Re: Beacon Solar Energy Project, AFC No. 08-AFC-2

**APPLICATION FOR CERTIFICATION FOR  
THE BEACON SOLAR ENERGY PROJECT**

Supplemental Response to CEC Data Request 14 and  
Responses to CEC Data Requests 71 through 127  
Docket No. 08-AFC-2

<b>BEACON SOLAR ENERGY PROJECT (08-AFC-02)</b> <b>CEC STAFF DATA REQUEST NUMBERS 71-78</b>	
<b>Technical Area: Biological Resources</b>	<b>Response Date: October 13, 2008</b>

**Figure DR-96c**  
**TDS Concentrations**  
**1999 -2007**

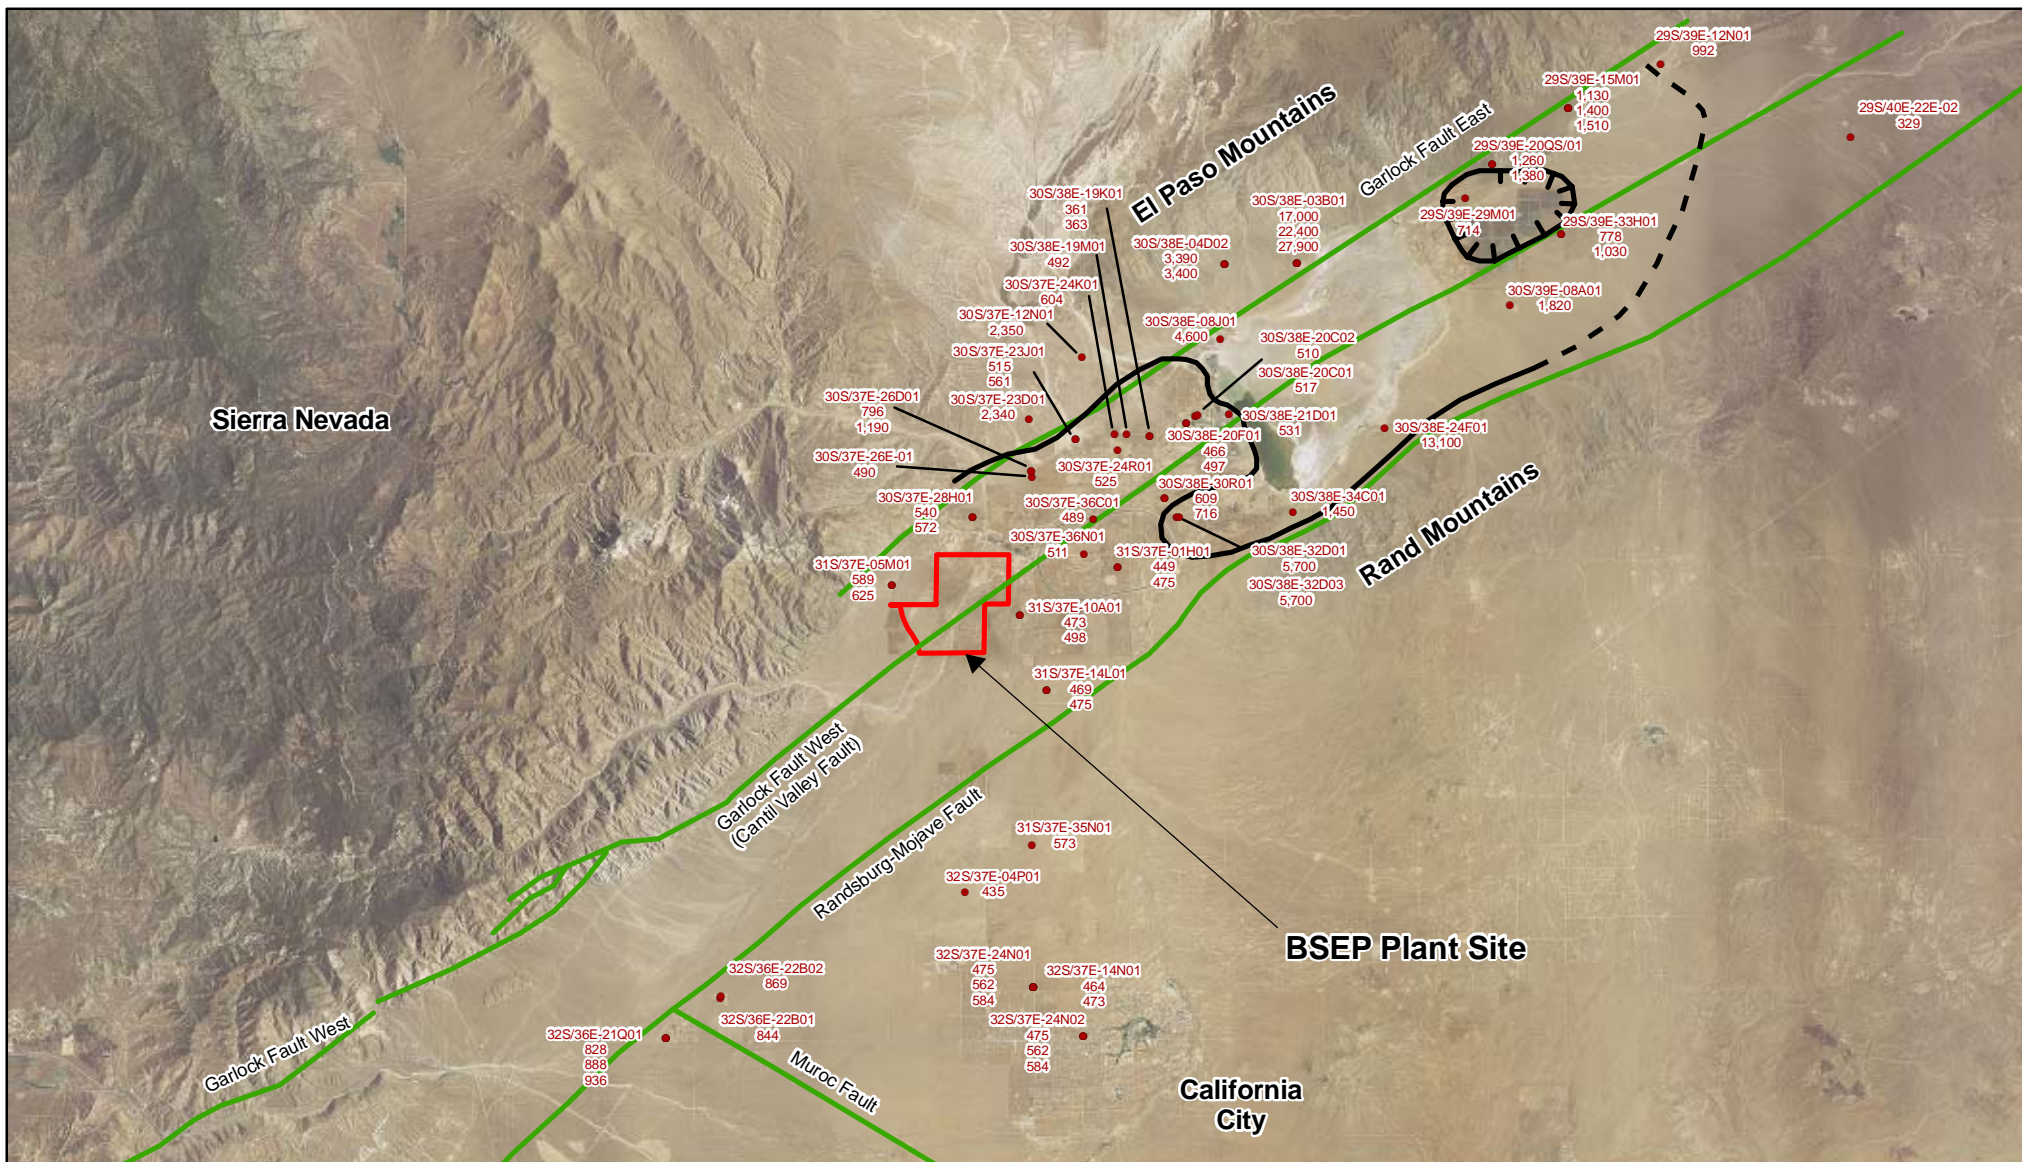
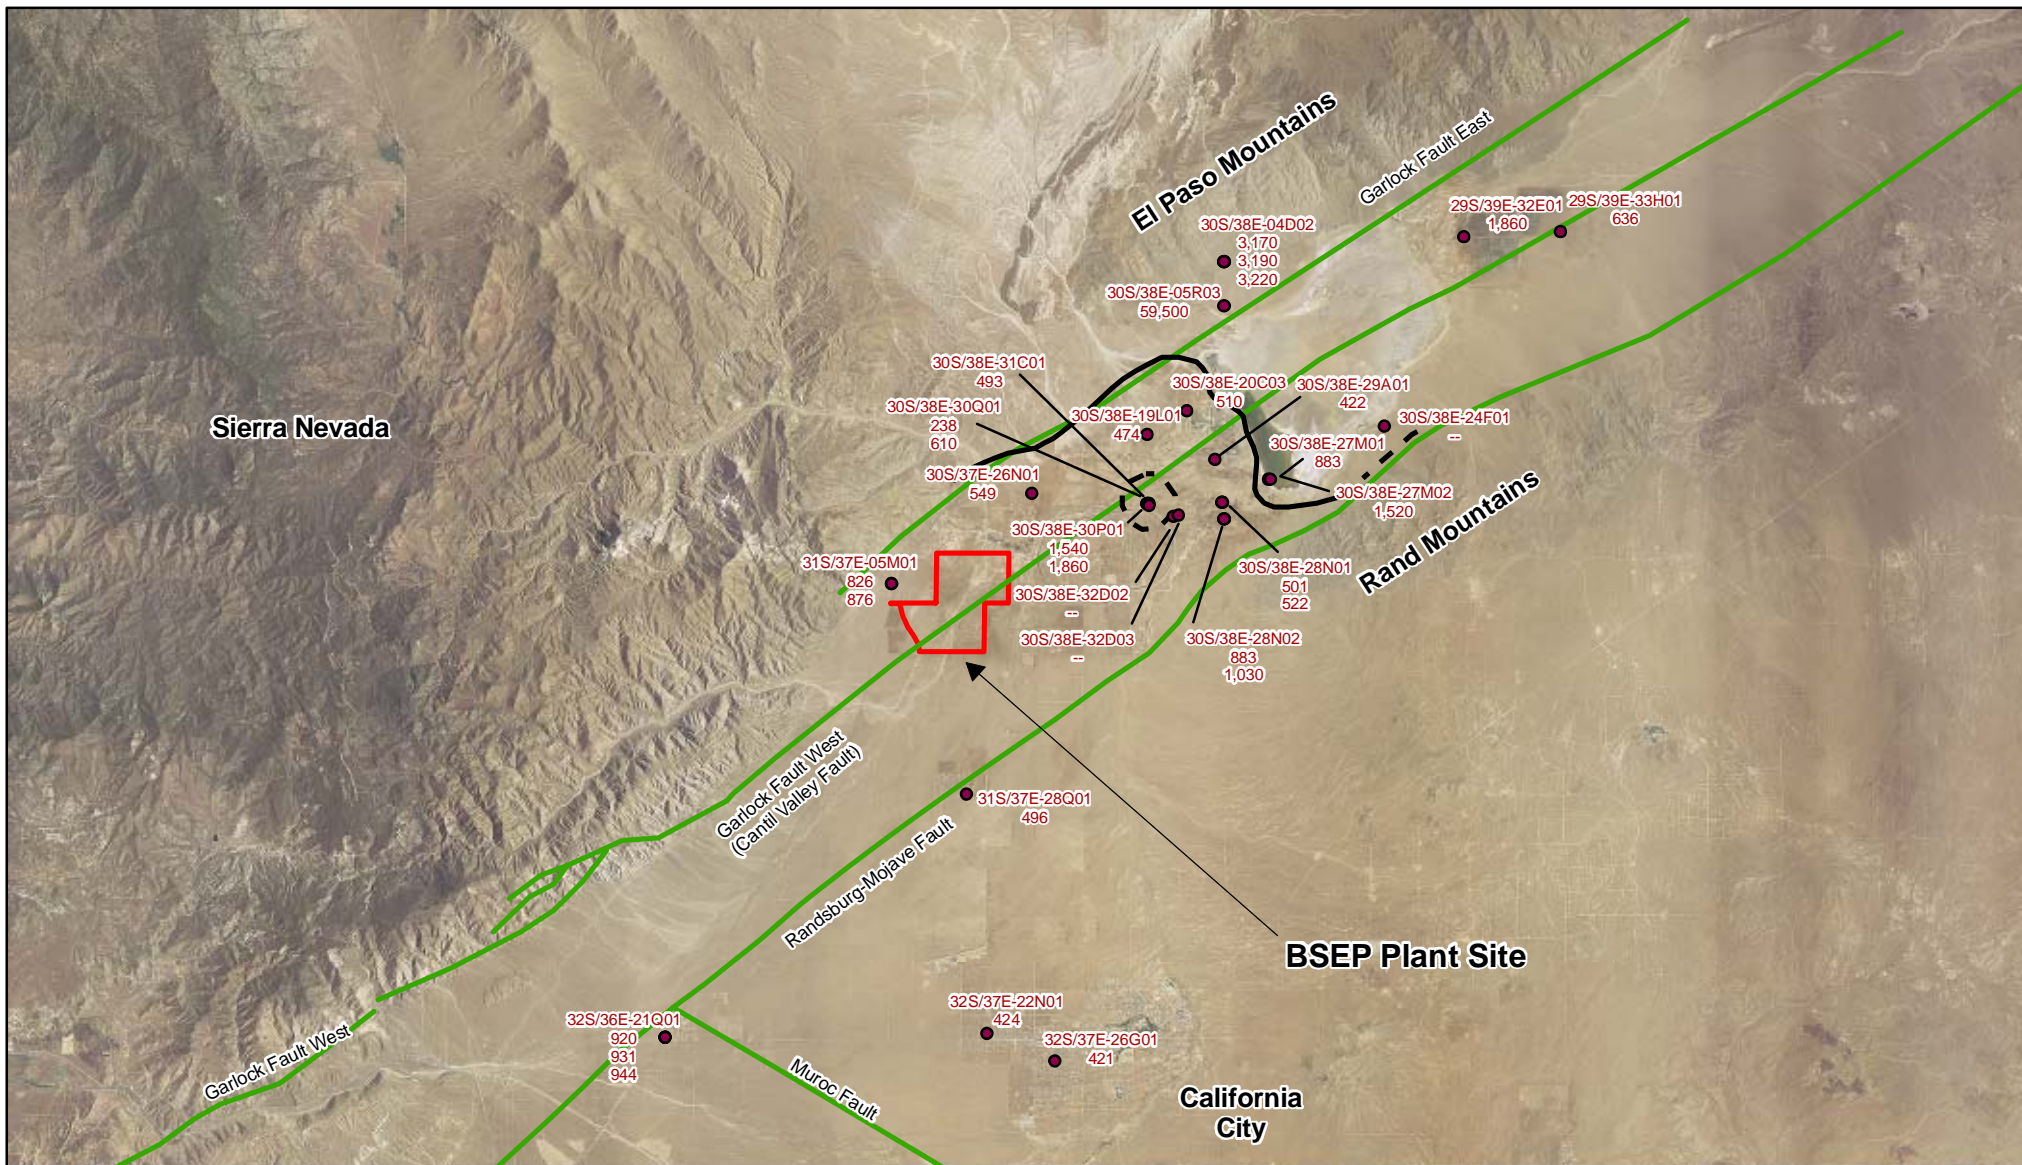
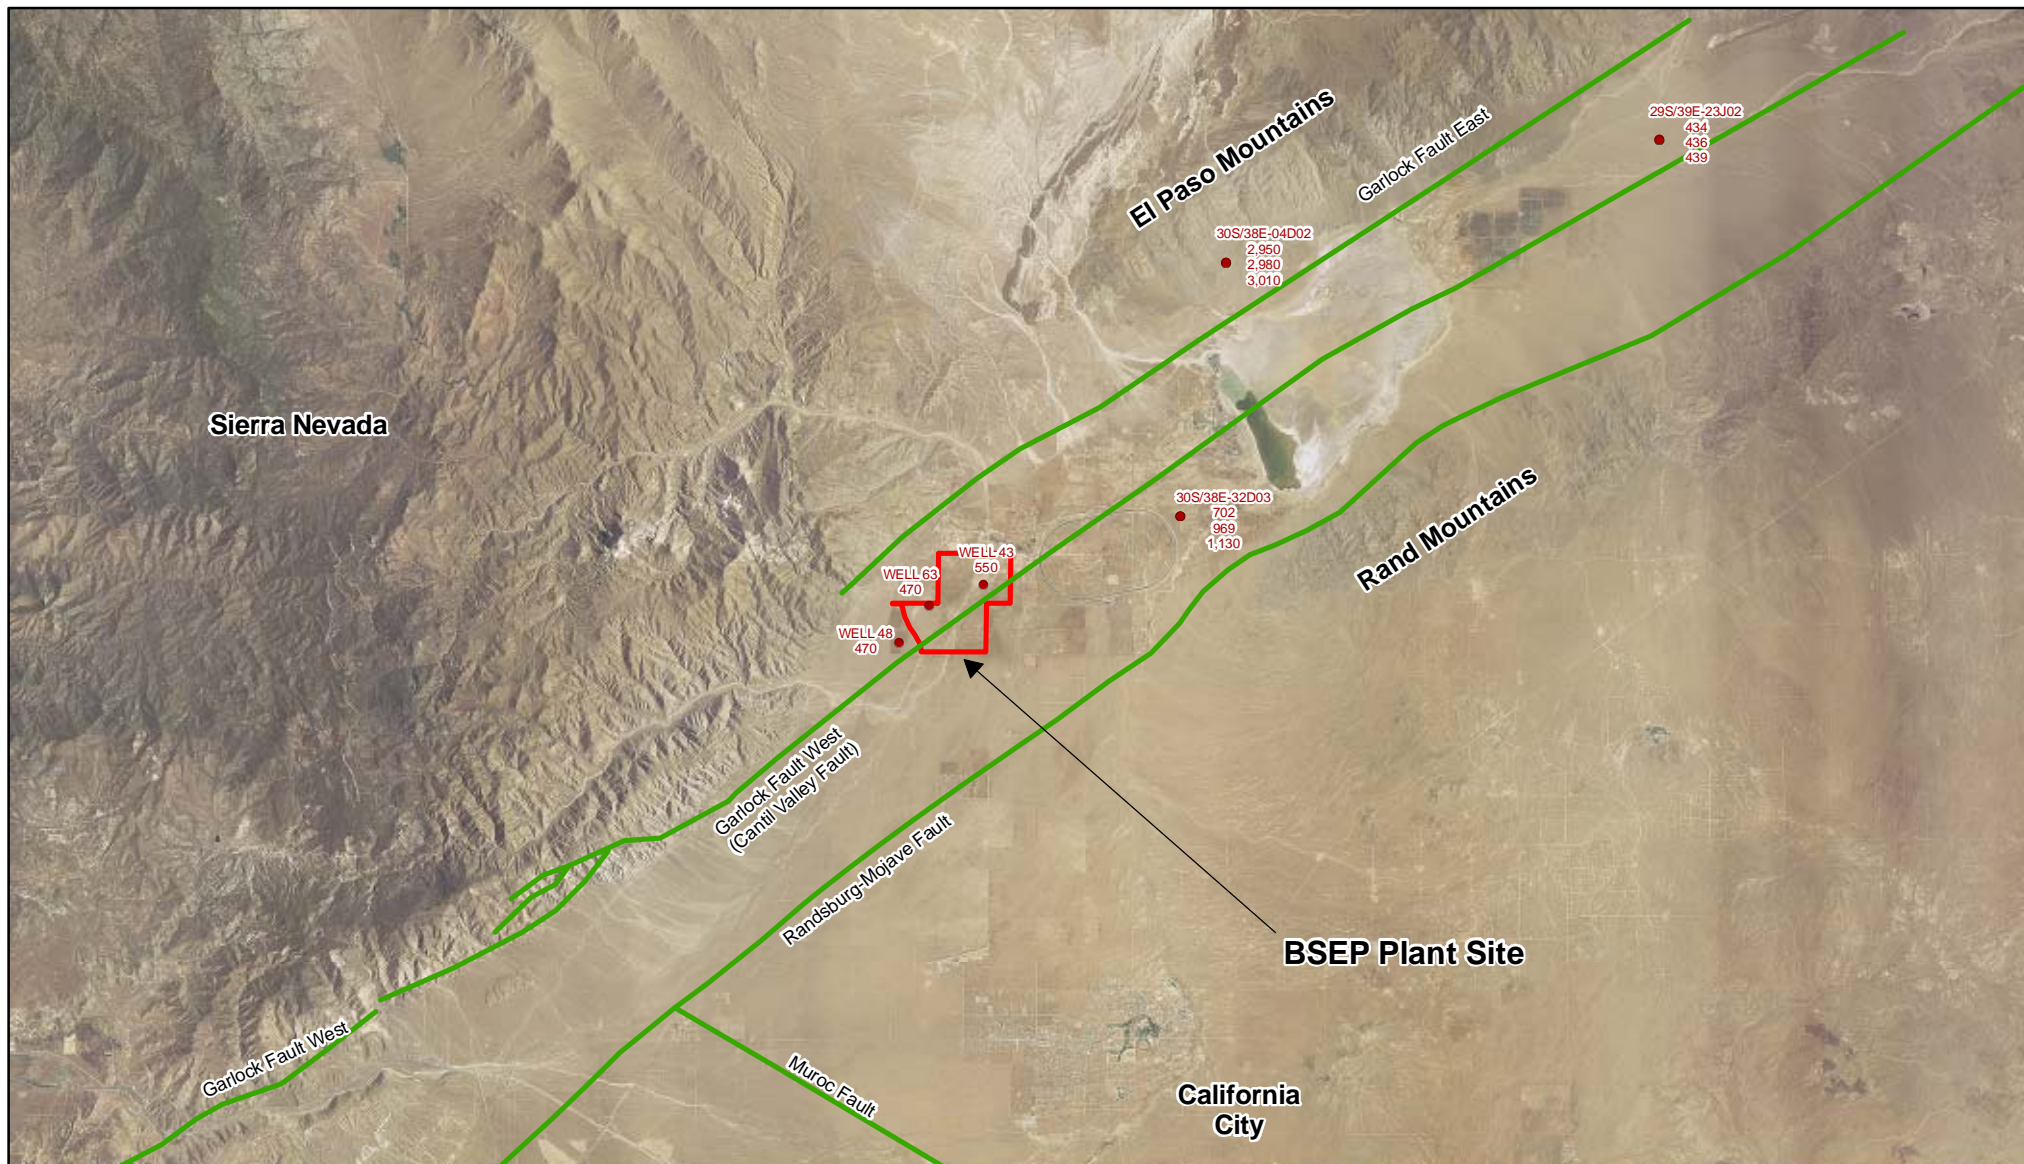
Please provide a map delineating the contemporary boundary between poor quality water (>1,000 ppm TDS) and high quality (<1, 000 ppm TDS) groundwater.

In response to this data request, separate figures (Figures DR-96a, DR-96b and DR-96c) were prepared showing available TDS data for the period of between 1953 to 1958, 1976 to 1978, and 1999 to 2007. These figures provide a time series of TDS concentrations within the Koehn Sub-basin. The periods were selected to show the most data over the widest geographic area within the sub-basin. The figures show that the most groundwater samples were collected during the period from 1953 to 1958 (i.e., 70 wells sampled), and that during subsequent periods, sampling was conducted in about one half the wells by comparison to the prior period. The data for these figures were taken from the geochemical database provided in Table J.4-1 of the AFC, and are summarized in Tables DR-96a (1953-1958), DR-96b (1976-1978) and DR-96c (1999-2007) attached.

Using a TDS concentration of 1,000 milligrams per liter (mg/L), the data for each of these time frames were contoured to show the distribution between poor and high water quality. As shown from the available data, the water quality has not varied significantly over time. Groundwater samples from wells located southwest of the lake, and in the direction of the Project site have consistently had TDS concentrations reported below 1,000 mg/L. Groundwater samples collected from wells between the Rand Mountains, south of the lake, and the El Paso Mountains, north of the lake, have had concentrations above 1,000 mg/L. There are few wells in these areas and those located north and south of the lake are generally situated at the margins of the lake or on the alluvial fans between strands of the Garlock Fault and Randsburg-Mojave Fault and Koehn Lake.

Figure DR-97 Township and Range in the Koehn Subbasin

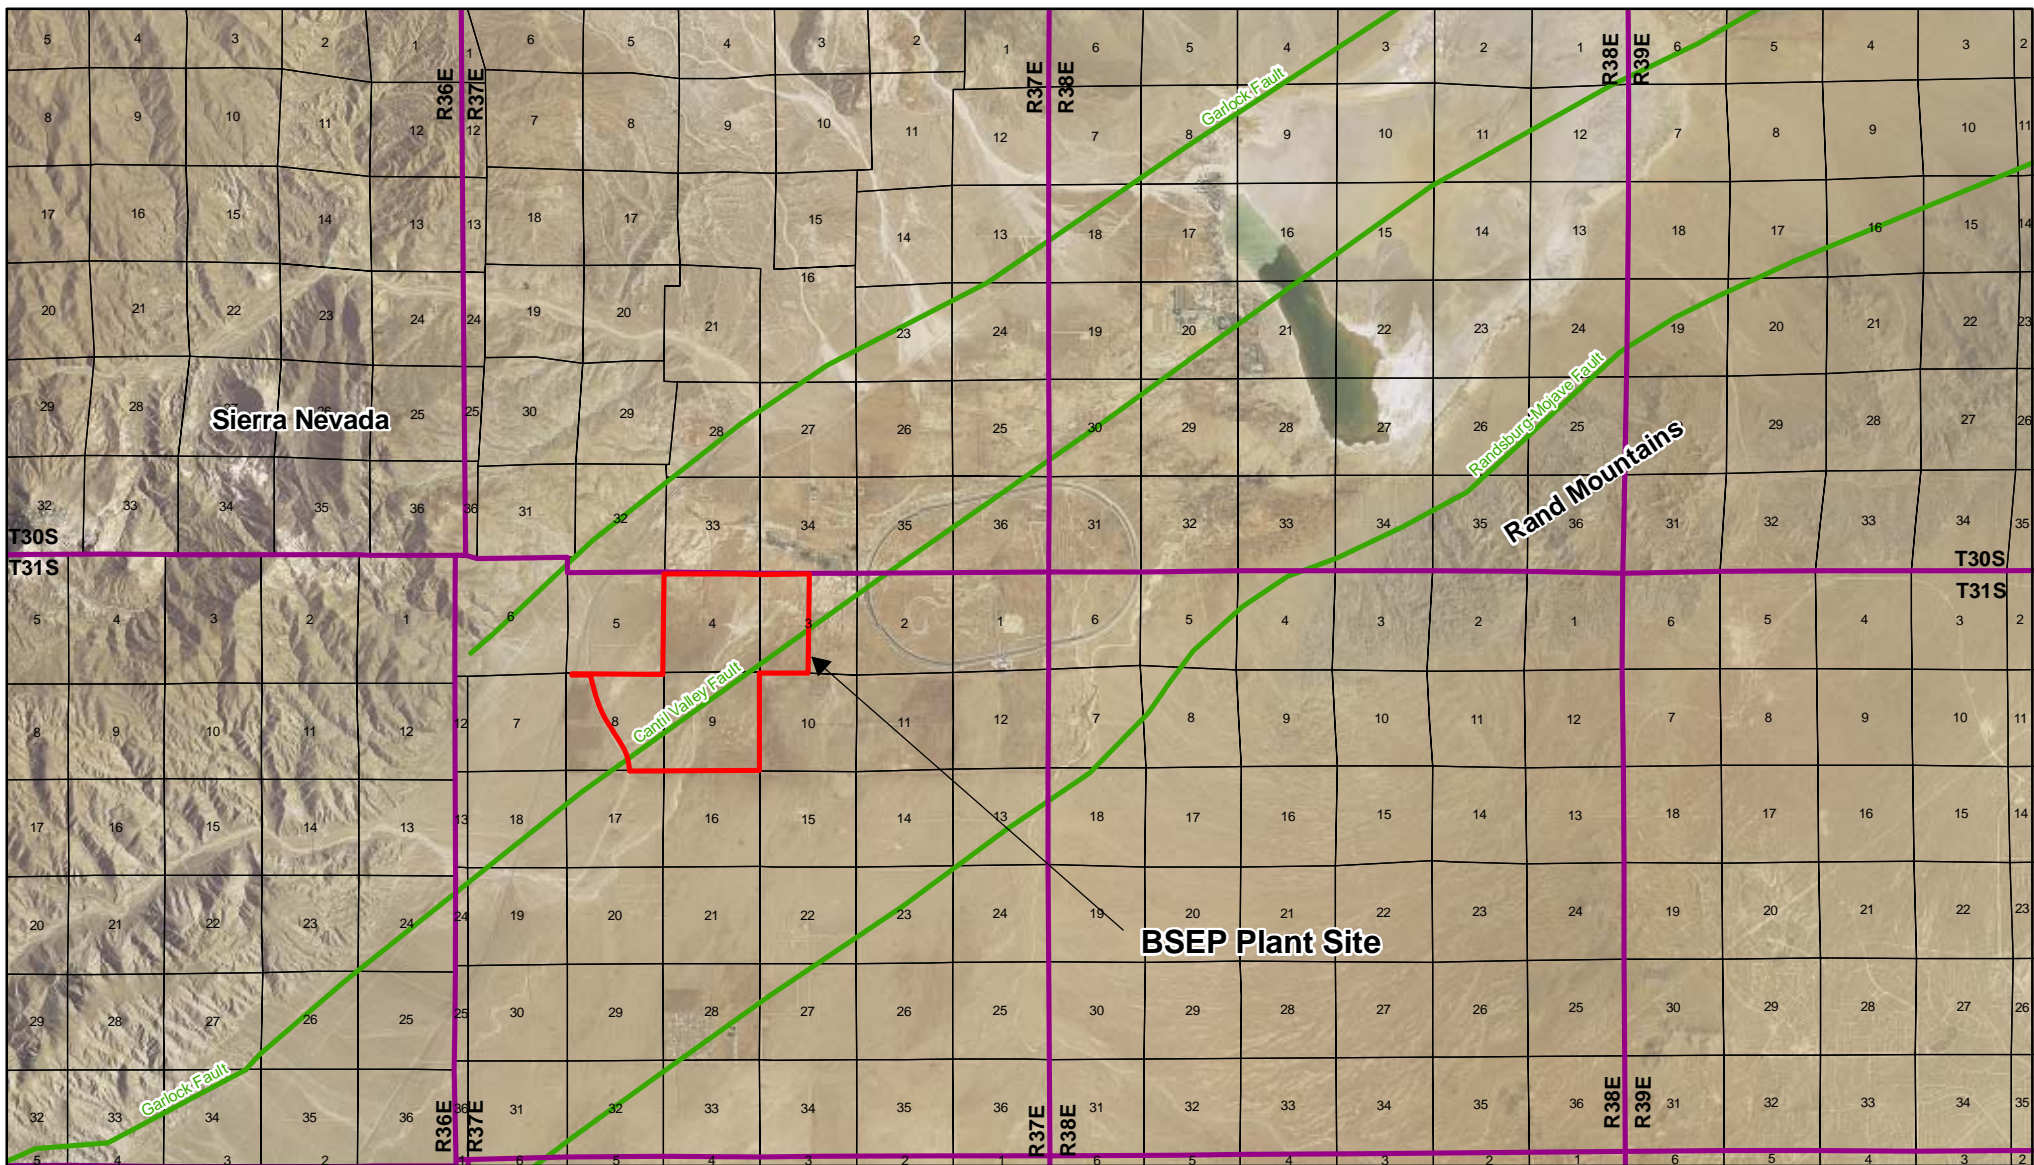
Please provide a map showing the locations of the wells described in Data Response #58.

Please see Figure DR-97 attached. This figure has been annotated to show township and range grids for the Koehn Sub-basin. In the response to Data Request No. 58, wells were referred in their corresponding township and range. Wells within Township 30 South and Range 38 East and Sections 21, 22, 23, 27, 28, 29, 32, 33 and 34 are located southwest of Koehn Lake, between the lake and the project site. These sections are at the southwestern margin and southwest of Koehn Lake. Groundwater samples from these wells have historically contained TDS concentrations below 1,000 mg/L, as shown on Figures DR-96a through DR-96c.
